TECHNICAL INFORMATION

61250

- Subject** ▶ Replacement of Hex. Socket Head Bolt
- For Models** ▶ 4604D
- Country** ▶ All countries
- Description** ▶ Hex. Socket Head Bolt M4x12 **without adhesive** (indicated by arrows below) have been replaced by Hex. Socket Head Bolts M4x12 **with adhesive** to prevent them from coming loose in use.

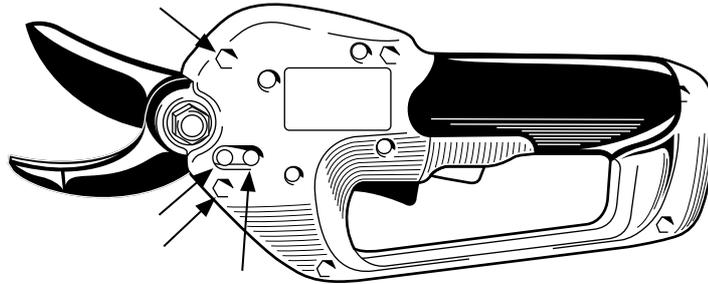
▶ Current	▶ New
Hex. Socket Head Bolt M4x12 without adhesive (Pt. No. 922118-6)	Hex. Socket Head Bolt M4x12 with adhesive (Pt. No. 266273-7)

From serial No. 4057E (May, 2000)
